ENTITLED: "AN ORDINANCE ANNEXING TO THE CITY OF CHEYENNE, WYOMING A PORTION OF SECTION 9, ALL OF THE W½ SECTION 14, ALL OF SECTION 15, A PORTION OF SECTION 16, AND ALL OF SECTION 21; TOWNSHIP 13 NORTH, RANGE 66 WEST OF THE 6TH P.M., LARAMIE COUNTY, WYOMING. (LOCATED TO THE SOUTHEAST OF THE INTERSECTION OF E. COLLEGE DRIVE AND AVENUE C)."

ANNEXATION REPORT

Sweetgrass Annexation Annexation Summation

CASE NUMBER: UDC-17-00542 **SUBDIVISION CODE:** SWET01

ANNEXATION MAP

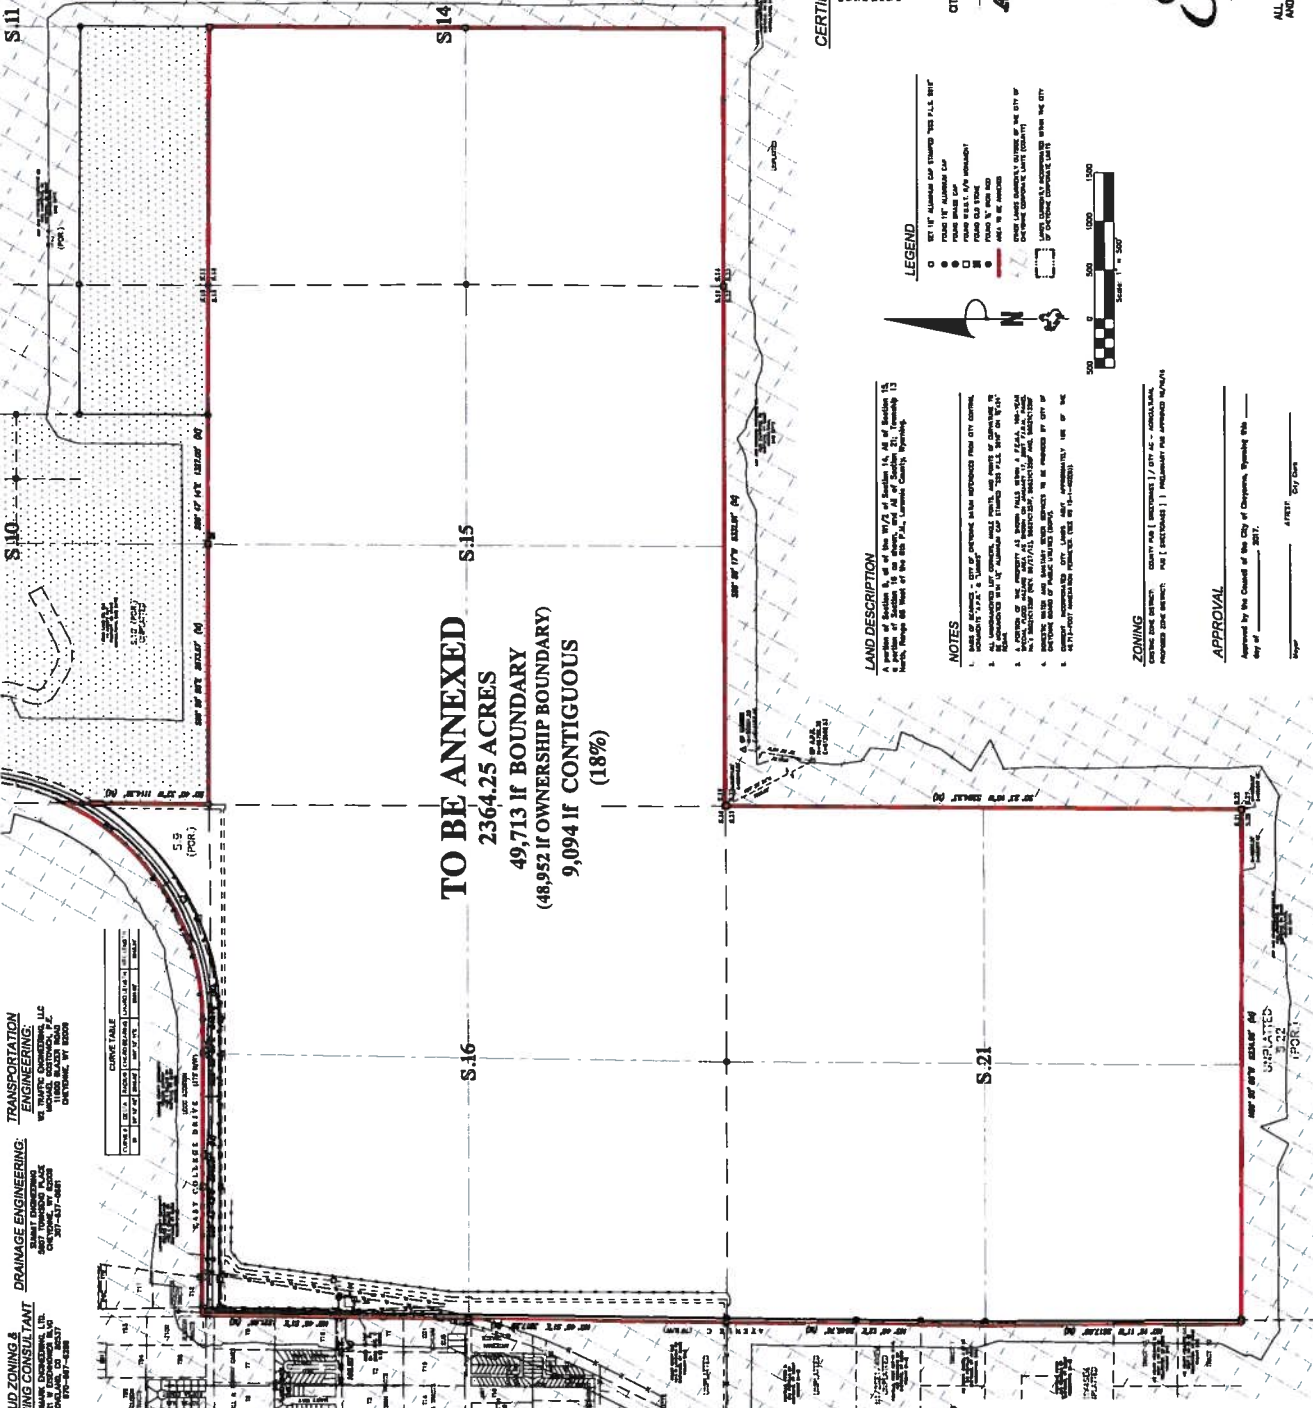
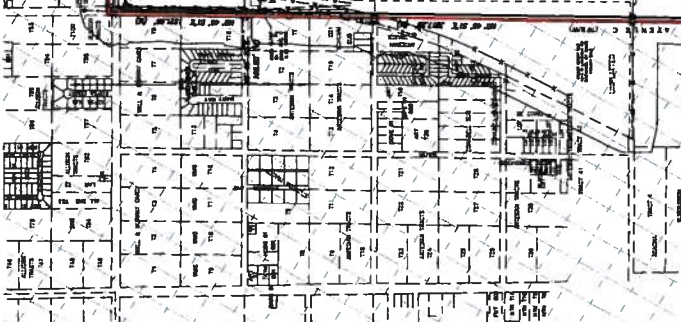
The first Note to Assessor is incomplete. The second Note does not apply to this development or annexation. (Planning Staff Note: Condition.)

As for the map, the minimum drawing requirements for the map appear to be met. Note to Assessor seems off... (Planning Staff Note: Condition.)

1. The boundary for the proposed annexation appears to include the East College Drive right of way, which I think should be occurring. However, the boundary data appears to only be the Southerly right of way dimensions. This is required to be clarified before I can double check closure and legal description. (Planning Staff Note: Condition.)

2. The legal description needs to be a full Metes and Bounds description, specifically identifying each course line followed. Eg.: a Section line; right of way line; etc. etc. A portion of Section 9 or 16 is adequate in the title block, but not the legal description. (Planning Staff Note: Condition.)

3. The NOTE TO ASSESSOR is not necessary on the Annexation map. (Planning Staff Note: Condition.)
4. The boundary data for the W1/2 of Sec. 14 is not provided. (Planning Staff Note: Condition.)

5. The boundary data for the NE1/4NE1/4 of Sec. 15 is not provided. (Planning Staff Note: Condition.)

1. Correct or remove the "Note to Assessor" section per comments made by the County Assessor and Planning and Development staff.
 2. Correct the boundary measurements, per comments by the City Surveyor.
 3. Correct the legal description to show a full metes and bounds description, per comments by the City Surveyor.
 4. Provide the boundary data for the W1/2 of Section 14 and the NE1/4NE1/4 of Section 15.
 5. Add "a portion of Section 9" to the title block to match the entitlement of the associated ordinance.
-
